Access Compliance Report

Public Rights-of-Way

(Curb Ramps)

Intersection ID: 54454	Main Street: COLLINGHAM_DR	Cross Street: STEELE_CREEK_RD	Location: SW
ADA ID: 2F4221CBD0E0	Ramp Type: Perp	Initial Pass/Fail: Fail	Overall Compliance: No
		Severity Score: 12.5

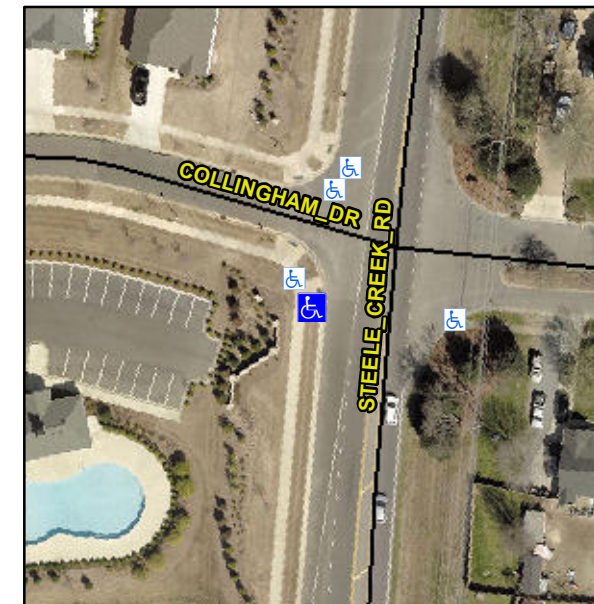
R304.2.2

Compliance	Description	Data	Compliance	Description	Data
N/A	Ramp Length (in)	97.0	No	Ramp Slope (%)	8.8
Yes	Ramp Width (in)	57.0	Yes	Ramp XSlope (%)	1.0
N/A	Flare Type LT	N/A	N/A	Flare Type RT	N/A
N/A	Flare Slope LT (%)	N/A	N/A	Flare Slope RT (%)	N/A
N/A	Flare Traversable LT?	N/A	N/A	Flare Traversable RT?	N/A
N/A	Landing Length (in)	N/A	N/A	DWS Provided?	N/A
N/A	Landing Width (in)	N/A	N/A	DWS Contrast?	N/A
N/A	Landing Slope (%)	N/A	N/A	DWS Length (in)	N/A
N/A	Landing X Slope (%)	N/A	N/A	DWS Full Width?	N/A
N/A	Landing Curb? (Y/N)	N/A	N/A	DWS Offset (in)	N/A
N/A	Shared Landing?	N/A			
N/A	Gutter Ponding?	N/A	N/A	Gutter Slope (%)	N/A
N/A	Gutter Lip Ht (in)	1.3	N/A	Gutter X Slope (%)	N/A
N/A	Painted X Walk1?	No	N/A	Painted X Walk2?	N/A
	X Walk 1 Direction	To SE		X Walk 2 Direction	N/A
N/A	X Walk 1 Width (in)	N/A	N/A	X Walk 2 Width (in)	N/A
	X Walk 1 Slope (%)	2.3		X Walk 2 Slope (%)	N/A
	X Walk 1 X Slope (%)	0.0		X Walk 2 X Slope (%)	N/A

Remove & Replace Entire Ramp.
